Post Construction Water Quality Monitoring Plan

For The
Gibson Dam Hydroelectric Project
FERC No. 12478-002

Dated
February 10, 2009

Figure 1.1. 2004 to 2008 combined DO monitoring results for Gibson Reservoir.

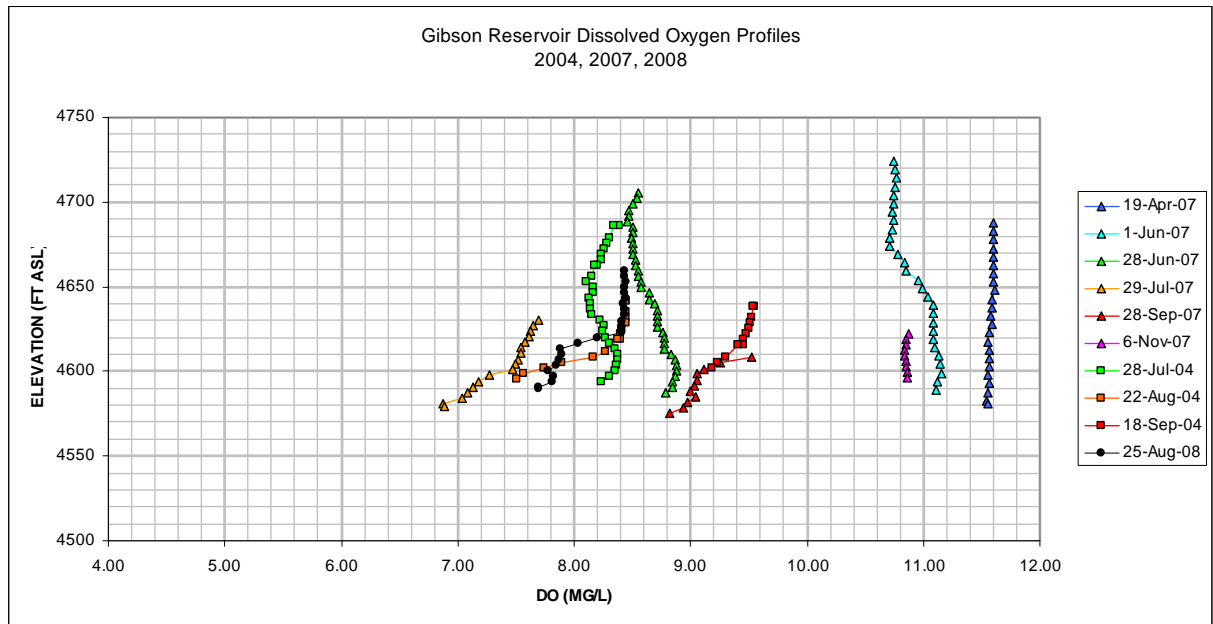
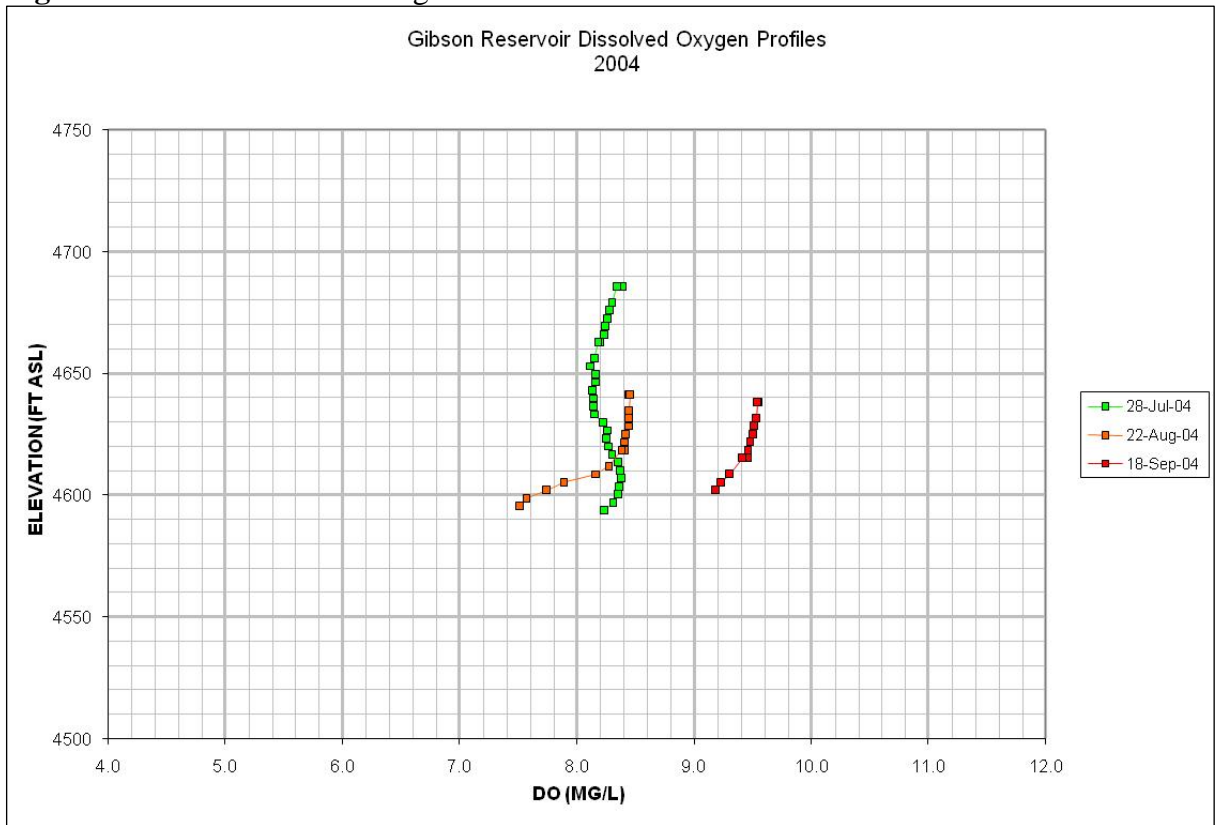
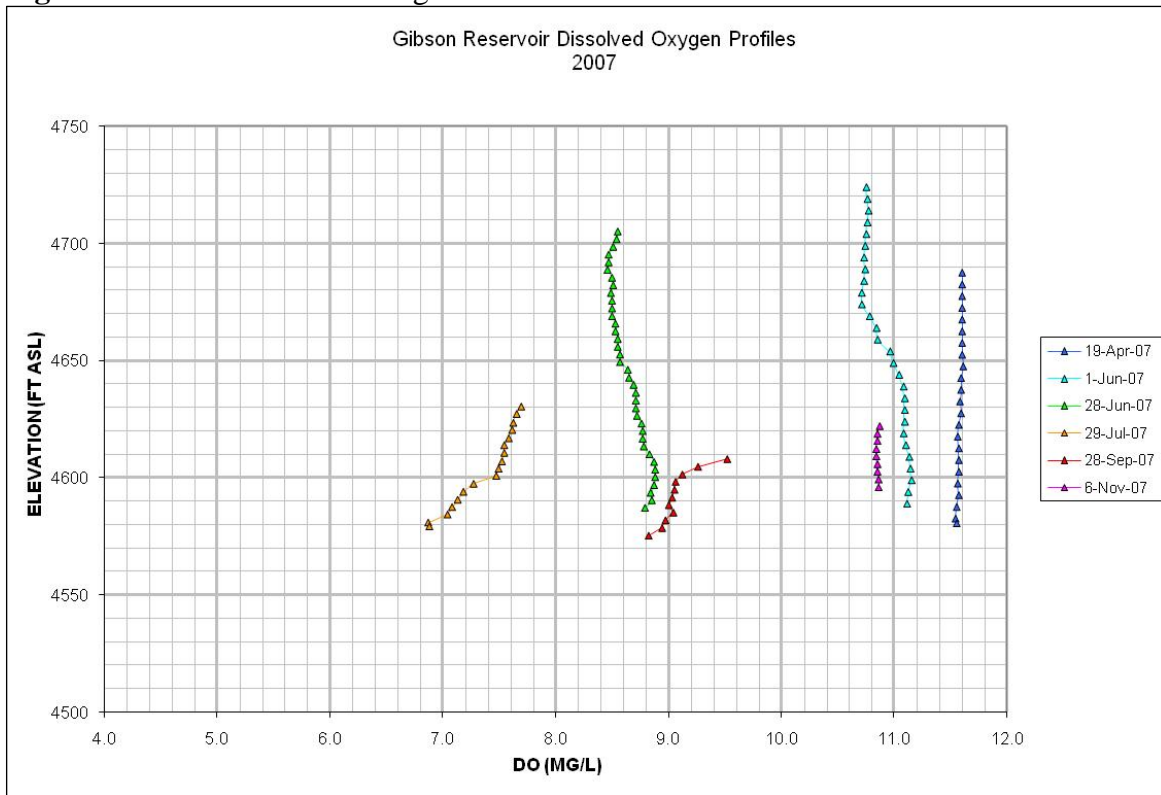
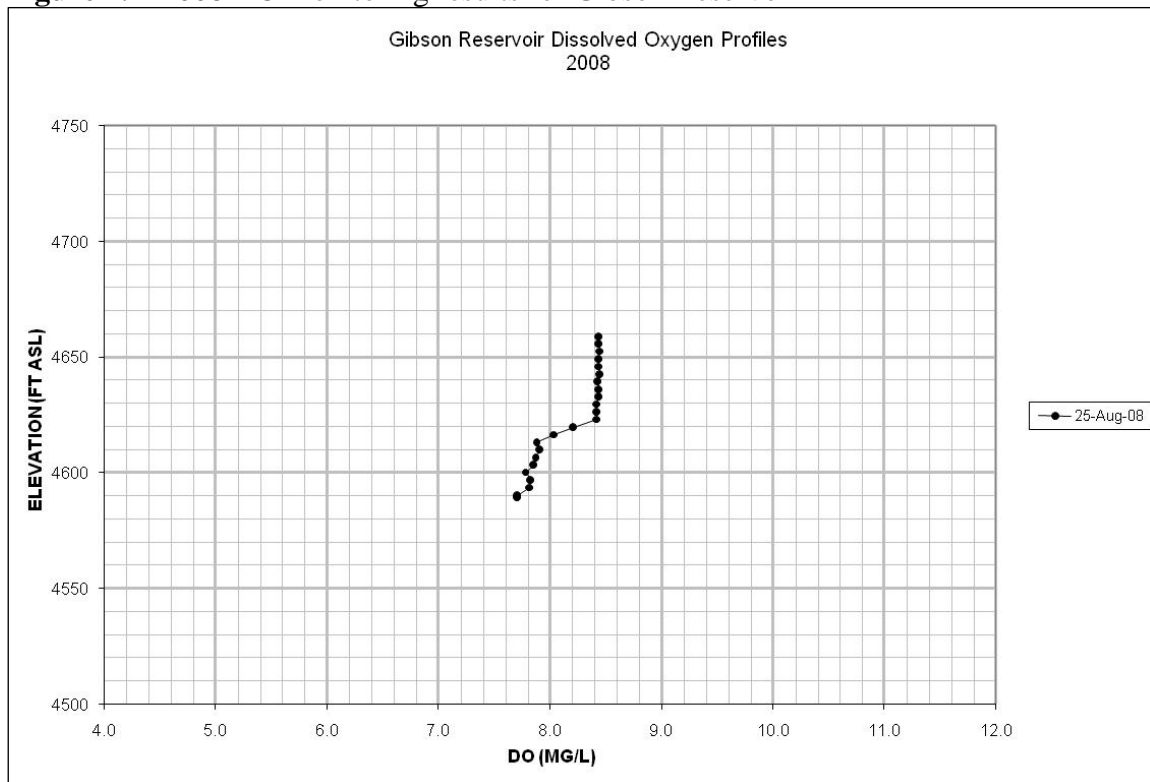
USFSZ USFSI
In the Water Quality Monitoring Plans, it would be helpful if the sampling location map showed more detail, such as roads and Diversion Dam. Also, the composite graph of Dissolved Oxygen levels for the three year period is difficult to tease out the important data. We request that the data be displayed graphically for both yearly and a three year period.

ID	Agency Comment	Applicant Response
DEQ1	Suggest adding sentence to end of last paragraph under Field Sampling Methods section to read “The dissolved oxygen meter will be calibrated prior to measuring DO at each site per the manufacture’s instructions.”	Added additional wording as suggested.
BOR1	No comment on Plan.	n/a
USFS1	Request to provide a more detailed sampling location map showing area landmark features.	Provided new sampling location map (Figure 2.) with additional detail as requested.
USFS2	Request to provide separate graph for each year of DO sampling results.	Provided separate graphs as requested.
